Addendum A

May 12, 2021

Project: Anderson County High School Girls Locker Room Renovation

SHEET INFORMATION
 SHEET ISSUED: 04/16/2021
 DESIGNED BY: KEF
 DRAWN BY: KEF
 REVIEWED BY: CMG
 SHEET TITLE: ENLARGED PLAN AND DETAILS

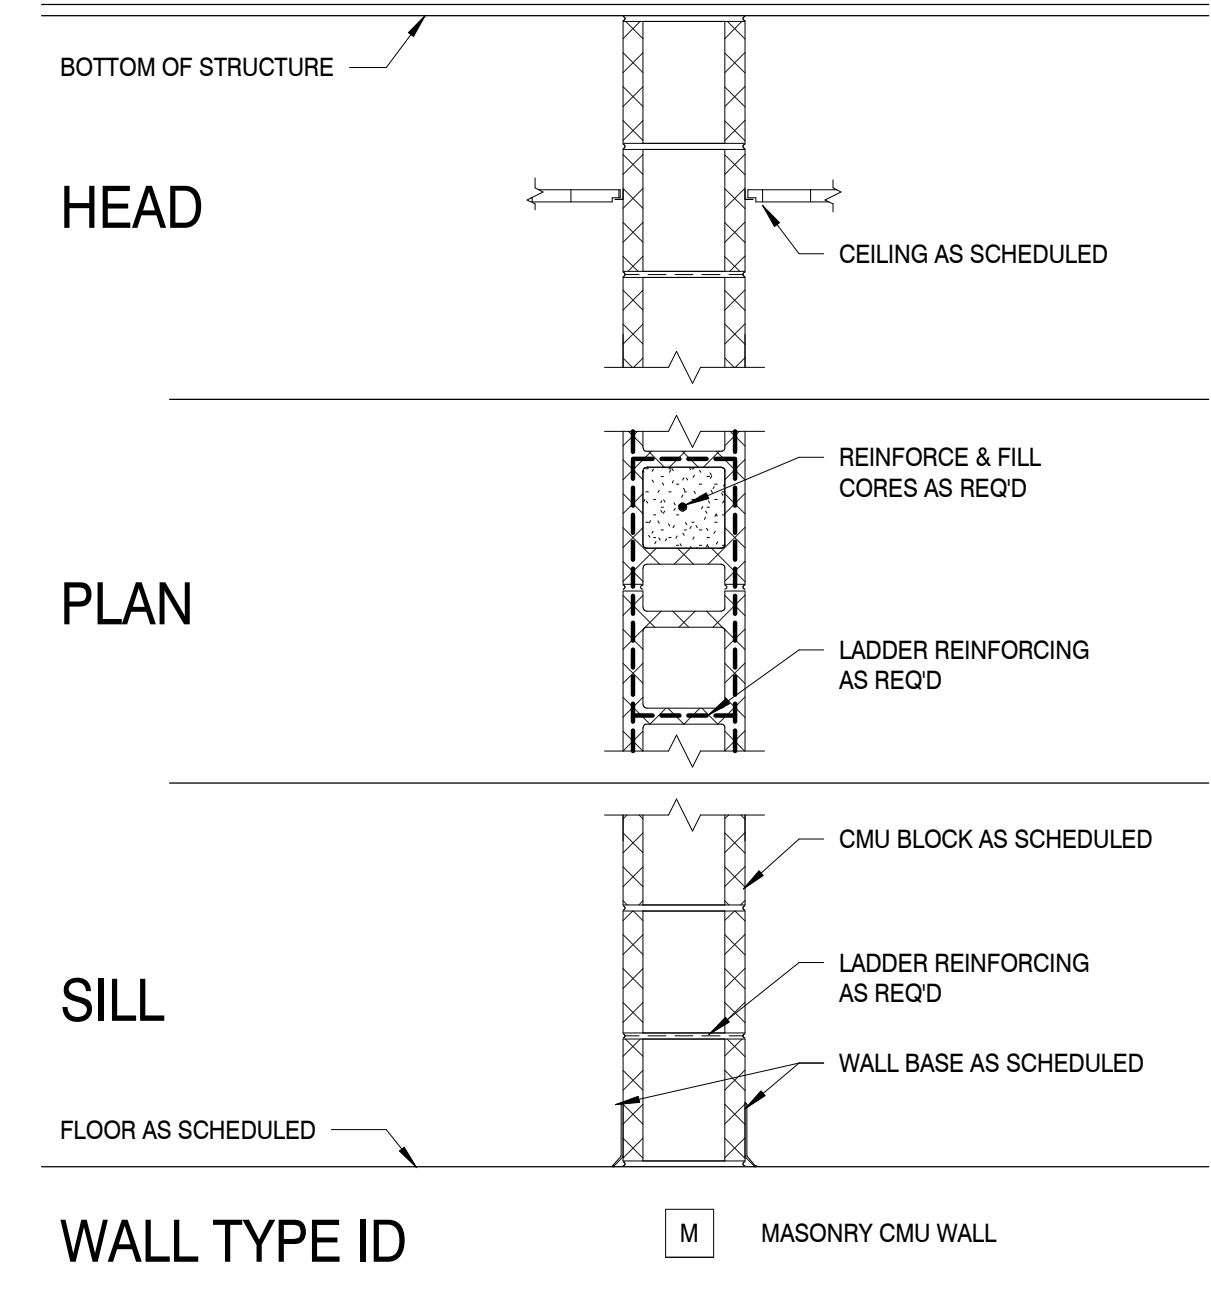
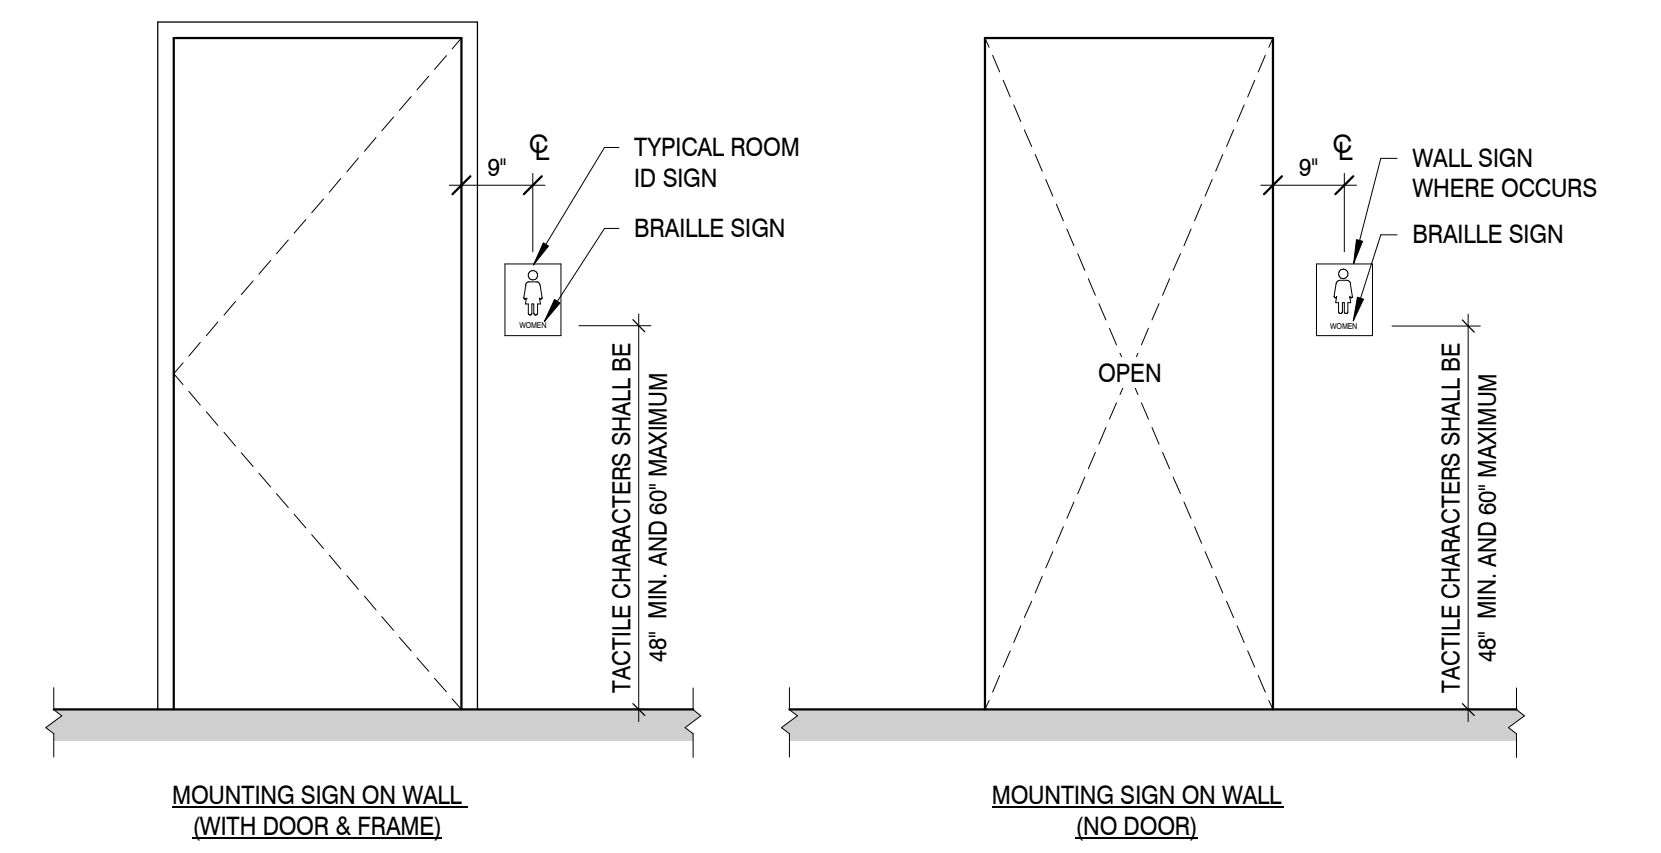
a. Answer: In addition to infilling the door, infill top of wall to ceiling deck with CMU to match existing wall.
7. Question: Do the new CMU walls go to the deck?

9. Question: Indicate signage locations.
a. Answer: See revised drawing sheet A601 Enlarged Floor Plan.
10. Question: There is no quartz drawn but it is listed in the finish schedule. Where is quartz to be installed?

a. Answer: Yes. See Wall Type ID on drawing sheet A601.
8. Question: Where are corner guards to be installed?
a. Answer: No corner guards, since exterior corners of CMU are specified to be rounded/bullnose. Corner guards removed from drawing sheet F101 Finish Schedule.

FINISH PLAN AND ELEVATIONS

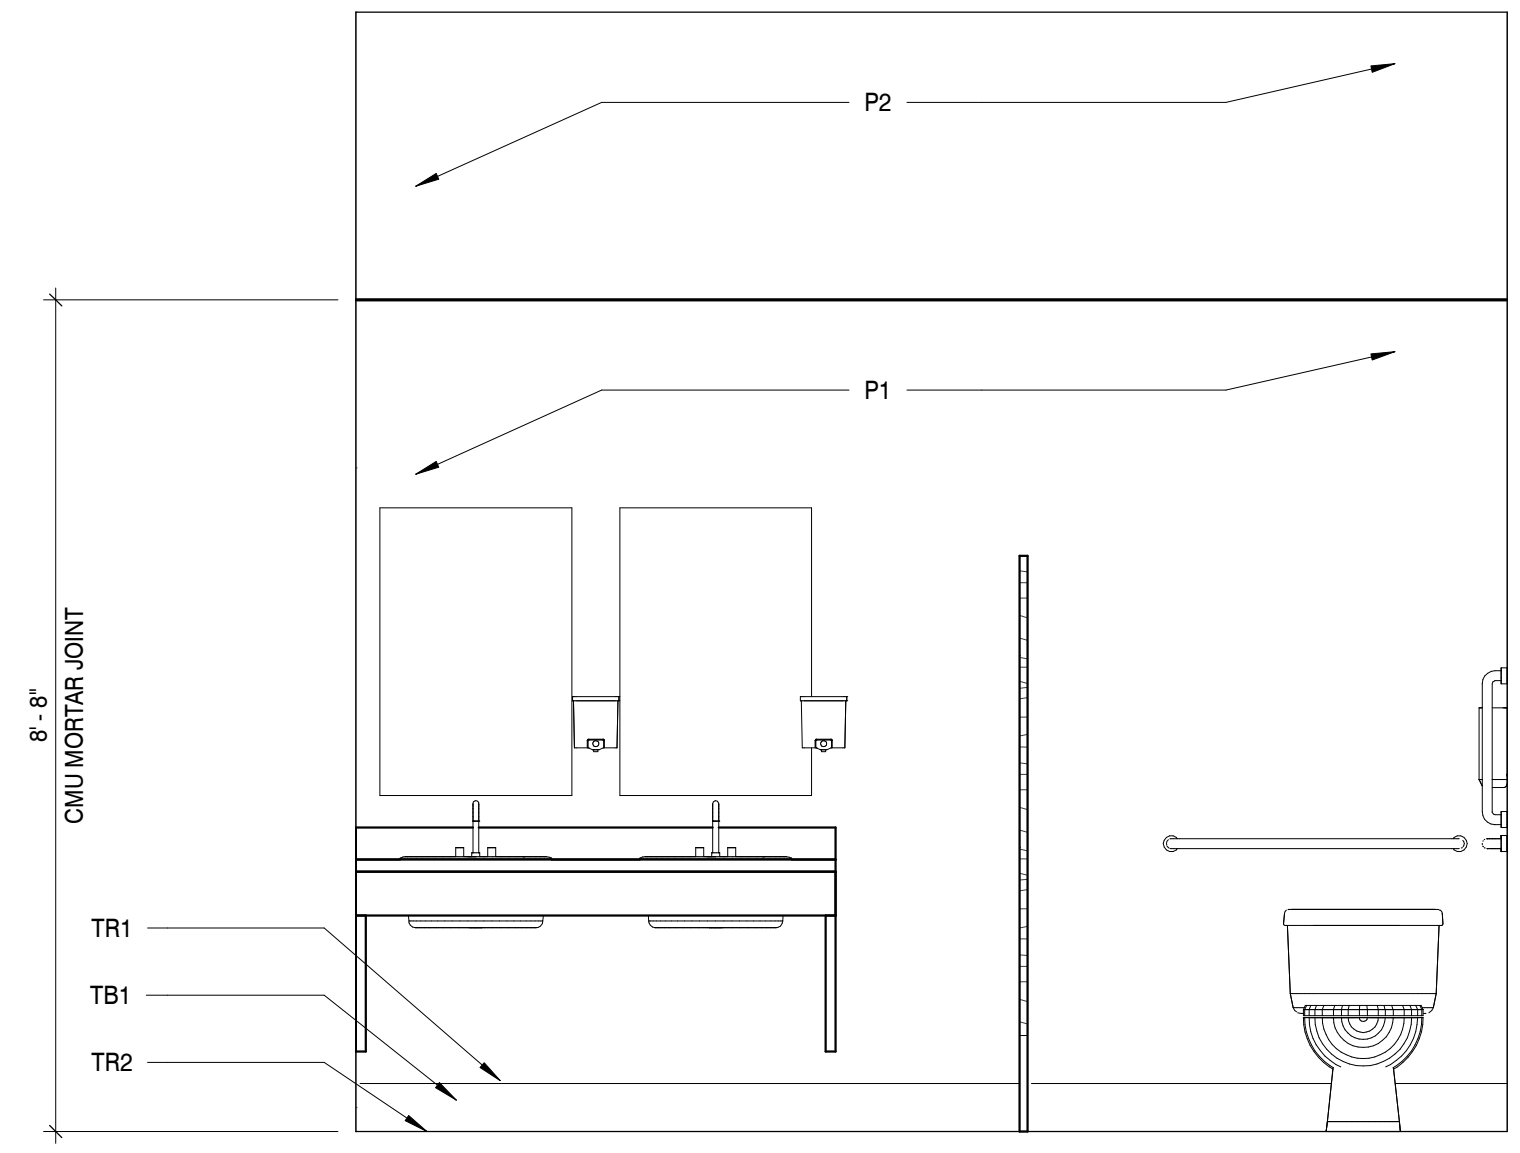
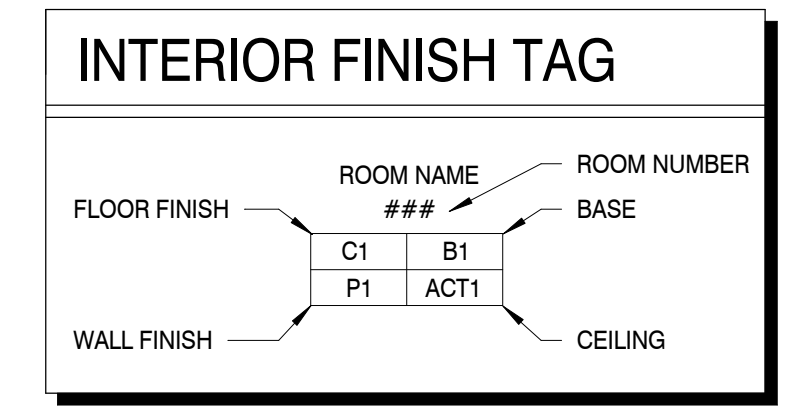
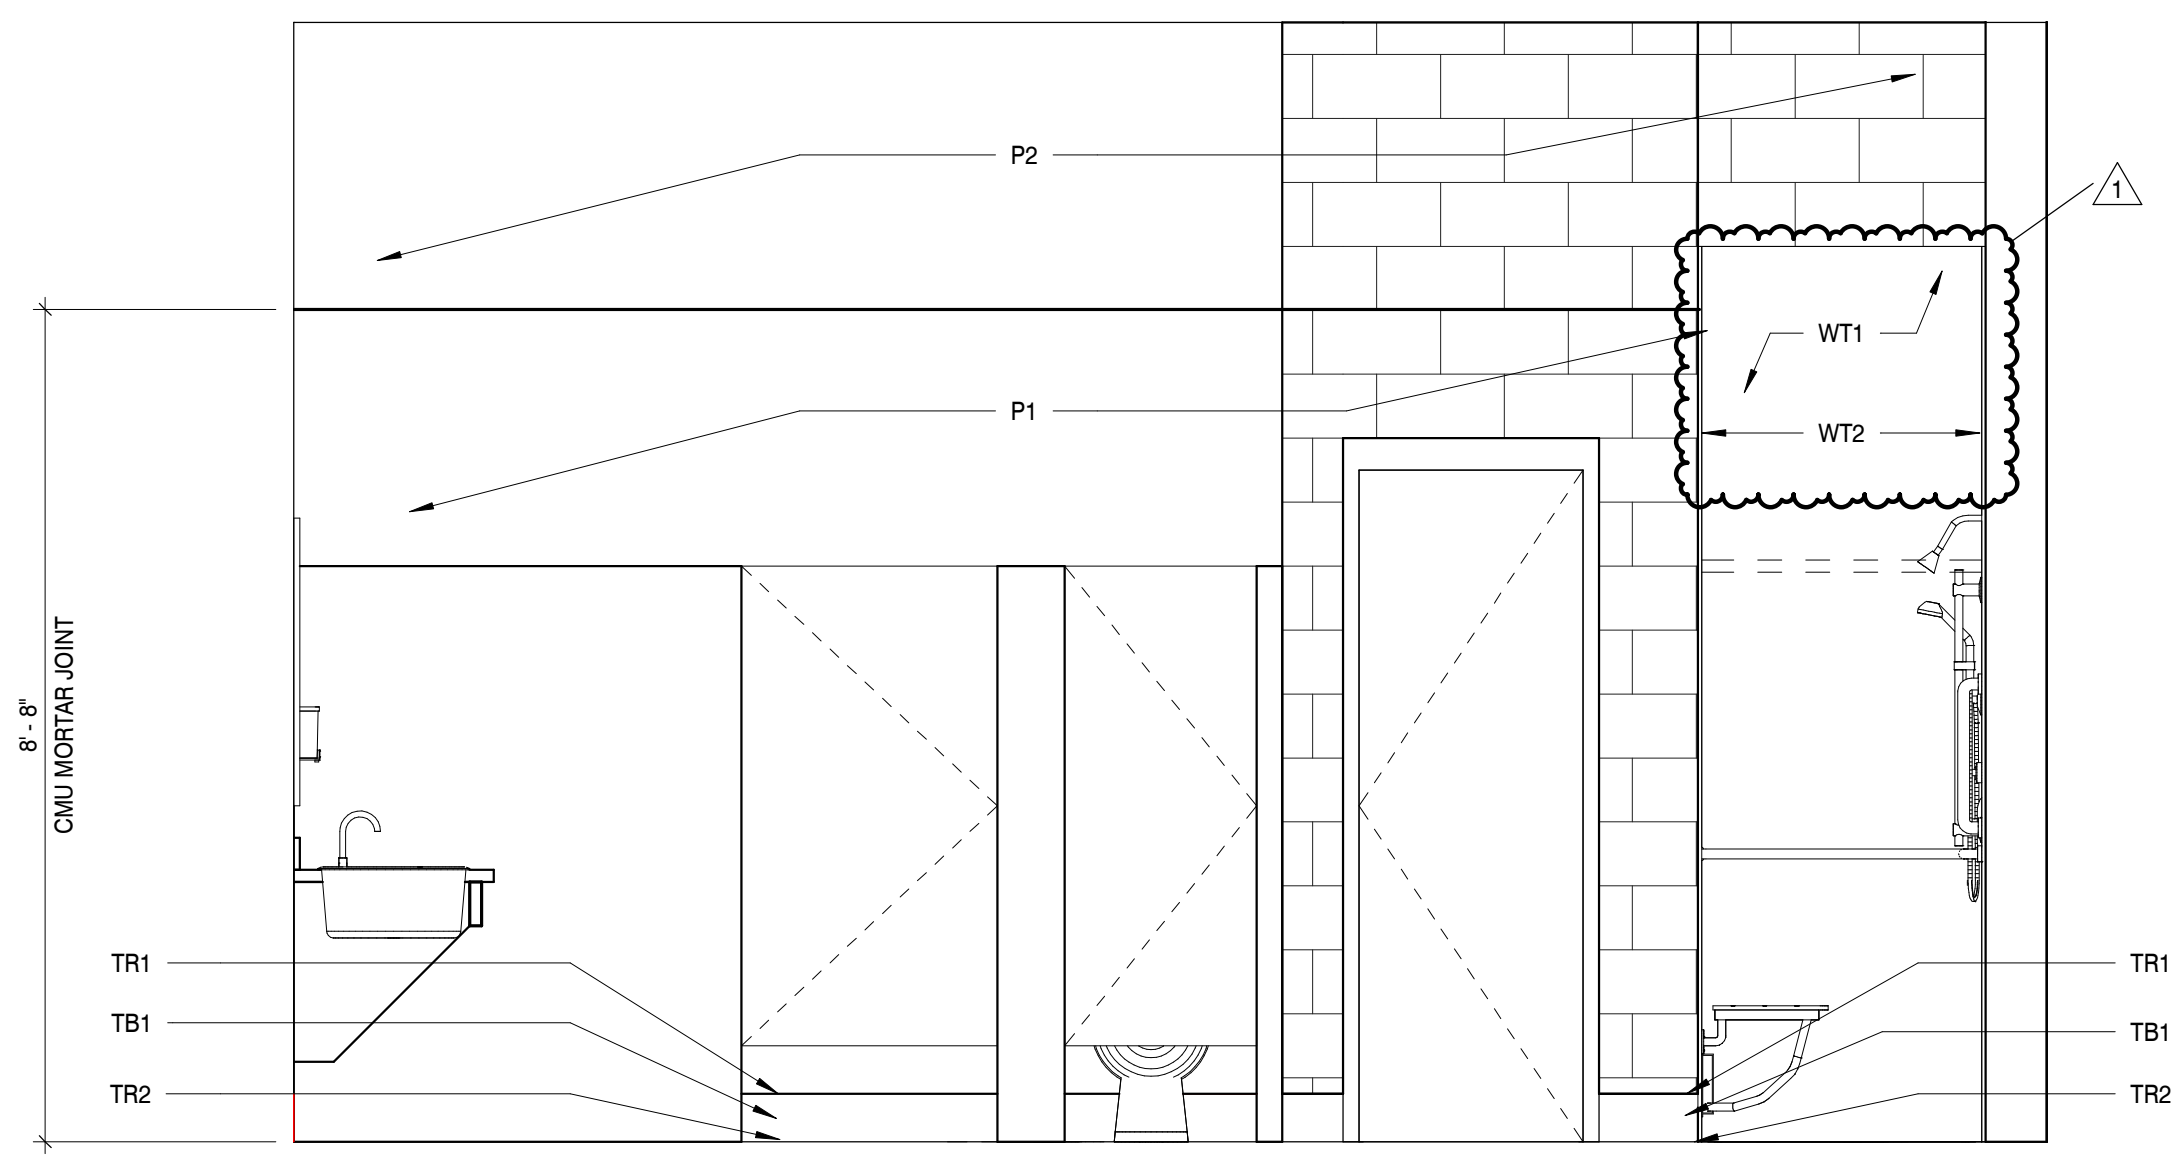
2. Question: Sheet F101, extent and height of wall tile WT1 & WT2?
a. Answer: See revised drawing sheet F101 Finish Plan, Toilet Wall Elevation, and Finish Schedule.

3. Question: Finishes on schedule, but not noted on plan - FT2, SC, QT1, TP1, CG
a. Answer: See revised drawing sheet F101 Finish Plan and Finish Schedule.

12. Question: Please provide elevations for wall finishes. Multiple wall finishes are listed for a single room but not elevations to determine where the finishes go.
 - a. Answer: See revised drawing sheet F101 Finish Plan, Toilet Wall Elevation, and Finish Schedule.

a. Answer: See revised drawing sheet F101 Finish Plan and Finish Schedule.
11. Question: Detail 1 on P201 shows existing water and sanitary in the wall but is currently wall mounted. Are we to leave the existing exposed plumbing exposed?
